201.5.2.7 PHY Control function, LS_PATH

201.5.2.8 PHY Control function, HS_PATH and LS_PATH

Figure 201–23—Infocfield TRAINING format, LS_PATH

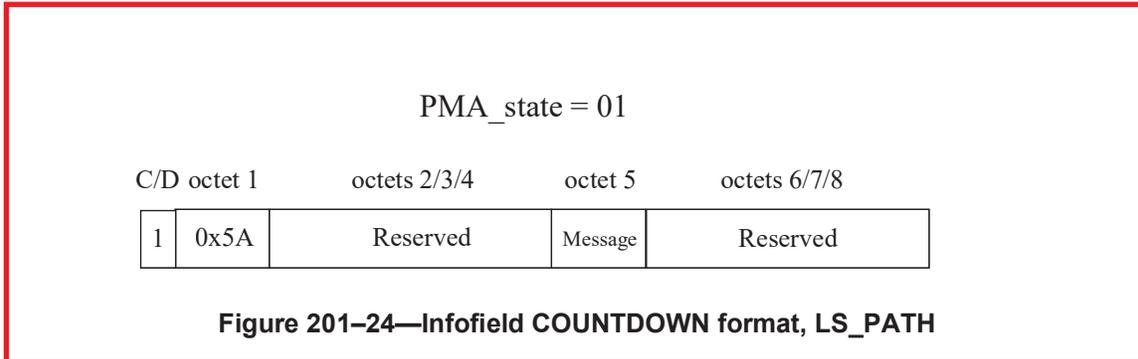
During PMA training (~~TRAINING and COUNTDOWN states~~ state in Figure 201-25), PHY Control information is exchanged between link partners with a 65-bit Infocfield, which is XORed with bits 195 to 259 of the PMA training frame, see 201.4.5. ~~The Infocfield is also denoted IF.~~ The link partner is not required to decode every ~~IF-Infocfield~~ transmitted but is required to decode ~~IFs-Infocfields~~ at a rate that enables the correct actions prior to the ~~PAM2-training~~ to ~~PAM4-data mode~~ transition.

The 65-bit Infocfield shall include the fields in 201.5.2.7.2 through 201.5.2.7.6, also shown in Figure 201-23 and ~~Figure 201-24~~. Infocfield shall be transmitted at least 128 times with each change to octets ~~6-5~~ to 8.

The two state-indicator bits PMA_state<7:6> shall communicate the state of the transmitting transceiver to the link partner. PMA_state<7:6> = 00 indicates TRAINING, ~~and PMA_state<7:6> = 01 indicates COUNTDOWN.~~

All possible Message Field settings are listed in Table 201–5 for the LEADER and Table 201–6 for the FOLLOWER; ~~however, the PMA_state<7:6> = 01 is not used by the LS_PATH.~~ Any other value shall not be transmitted and shall be ignored at the receiver. The Message Field setting for the first transmitted PMA frame shall be the first row of Table 201–5 for the LEADER and the first or second row of Table 201–6 for the FOLLOWER. Moreover, for a given Message Field setting, the next Message Field setting shall be the same Message Field setting or the Message Field setting corresponding to a row below the current setting. When loc_rcvr_status = OK the Infocfield variable is set to loc_rcvr_status<5> = 1 and set to 0 otherwise.
